ADDENDUM NO. 2

Kau Water System Improvements – Phase 1

IFB No.: IFB-20-HHL-019

2 TYPICAL GUARDRAIL ELEVATION
S-18 SCALE: 1/2" = 1'-0"

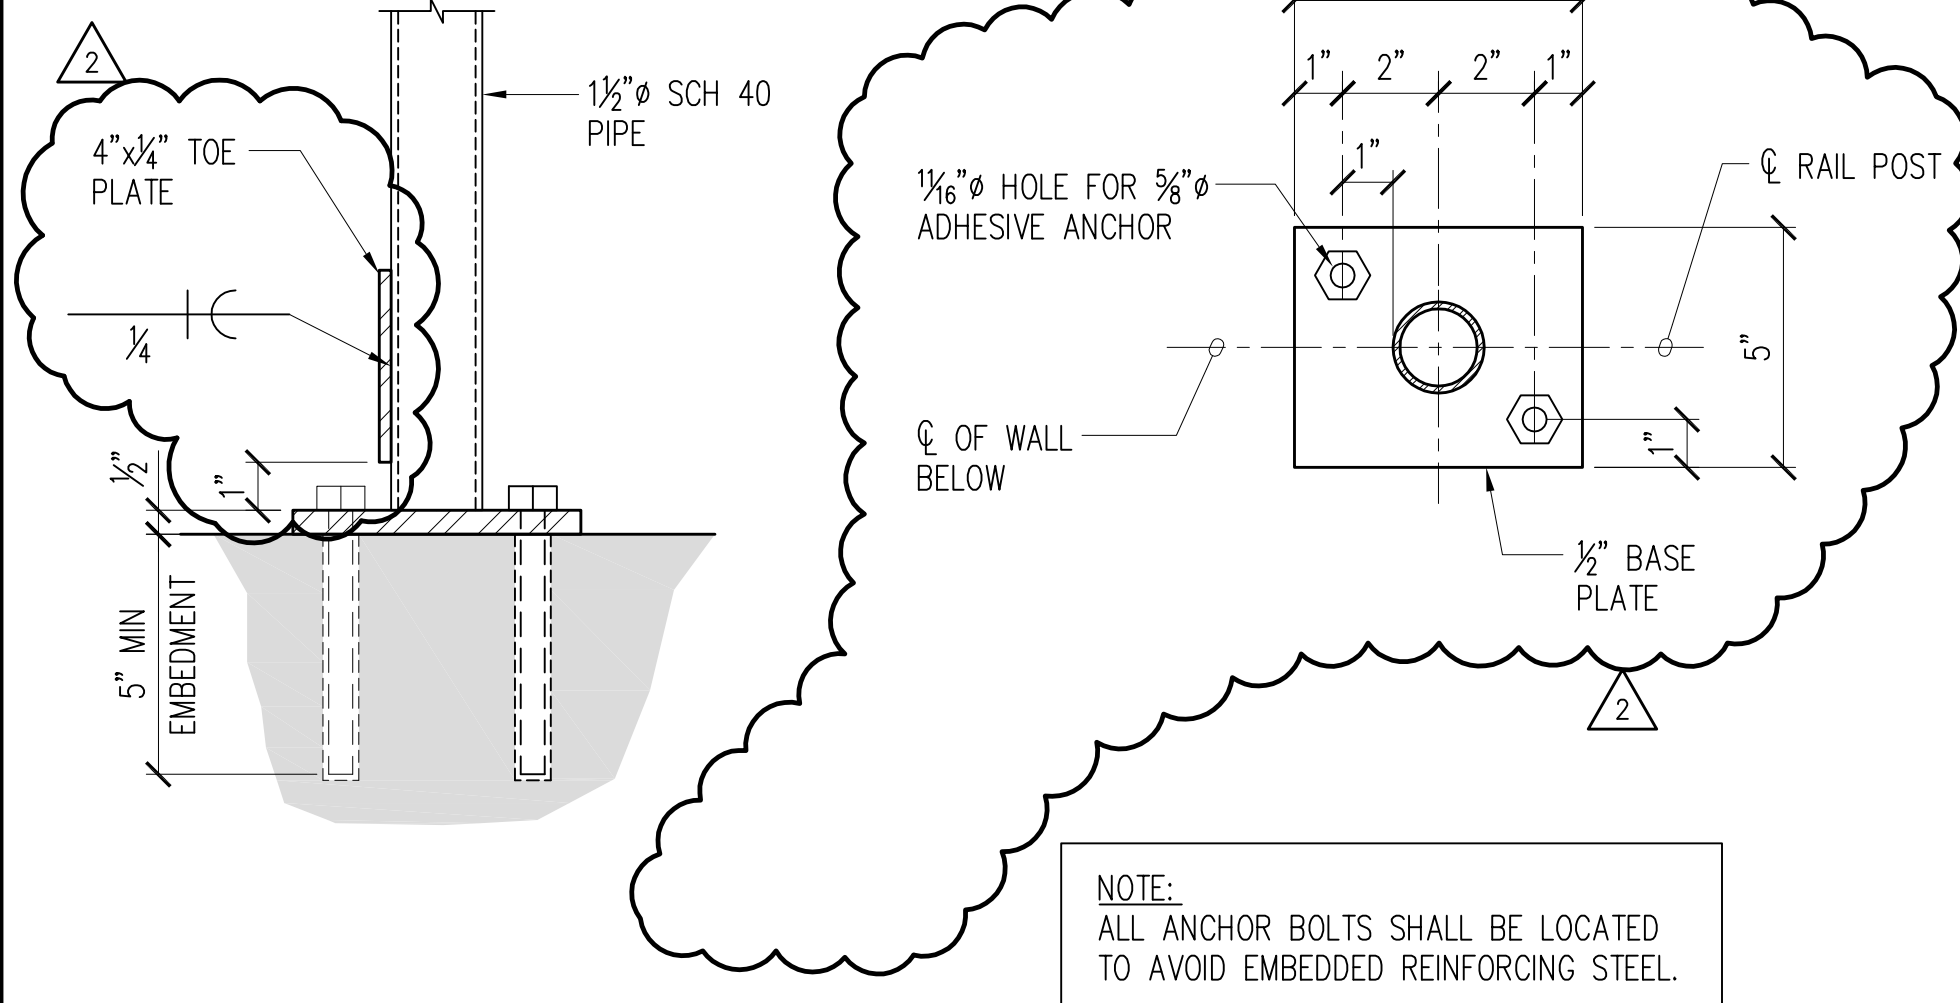
35. PLANS: DETAIL 1/S-18 – Removed concrete roof curb and roof opening dimension; added guardrail toe plate.
36. PLANS: DETAIL 2/S-18 – Removed concrete roof curb; added guardrail toe plate.

DWG. NO.
E-2
SHEET 48 OF 54

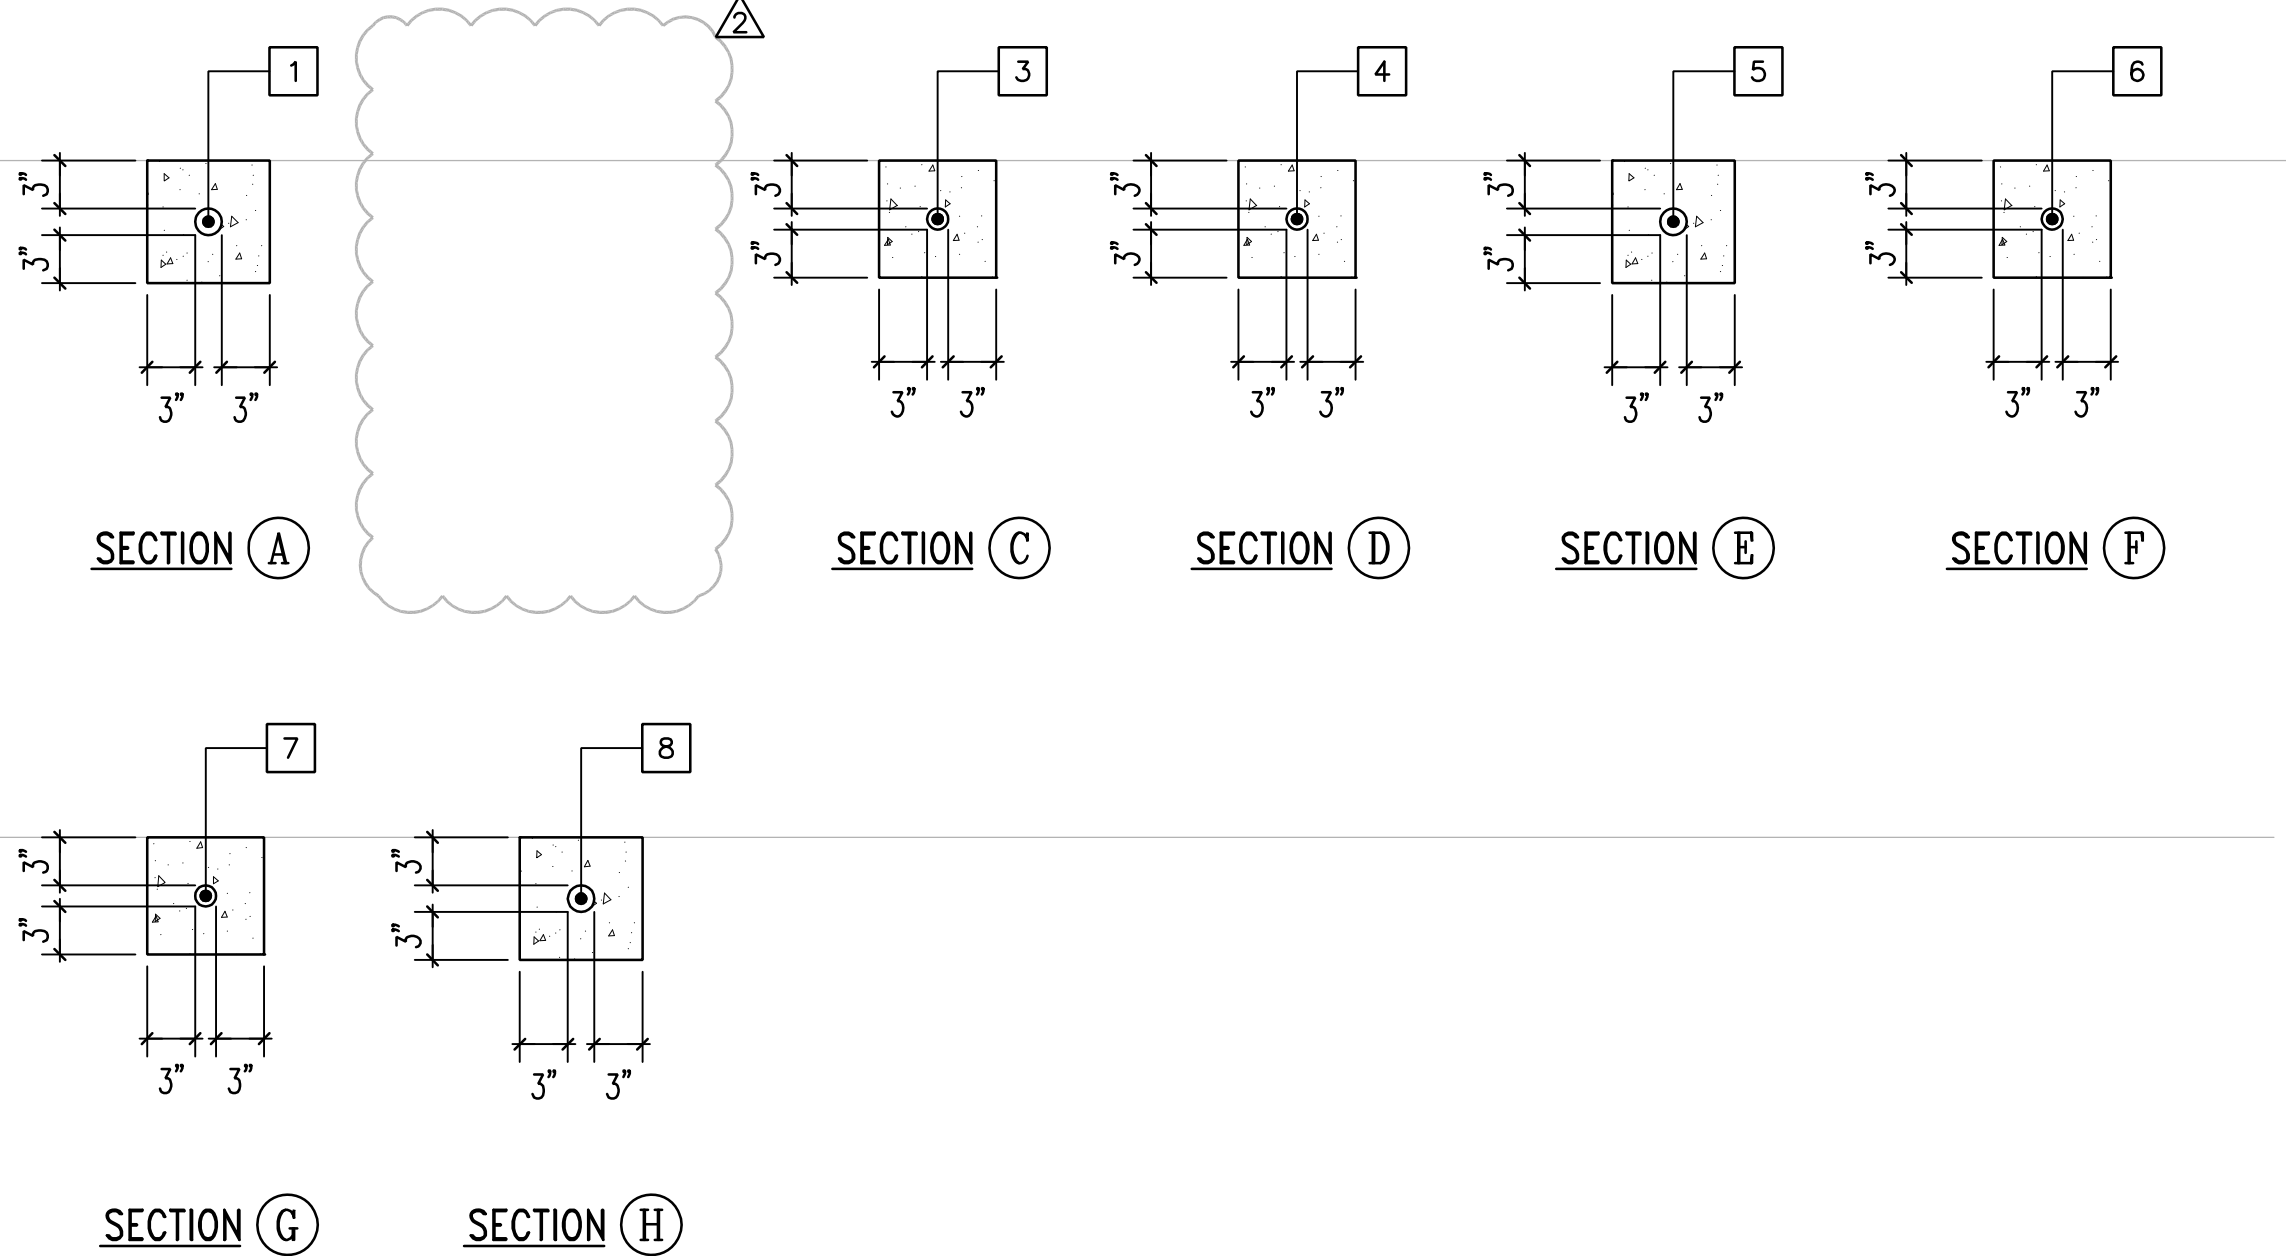
1. PLANS: DRAWING E-2 – Removed Duct Section B. The combination pressure relief and solenoid control valve has been removed.
2. PLANS: DRAWING E-4 – Removed electrical work for the combination pressure relief and solenoid control valve.
3. PLANS: DRAWING E-7 – Per DWS, the flow meters and level transmitters shall be modbus. Revised the SCADA diagram to reflect modbus connections and not analog.
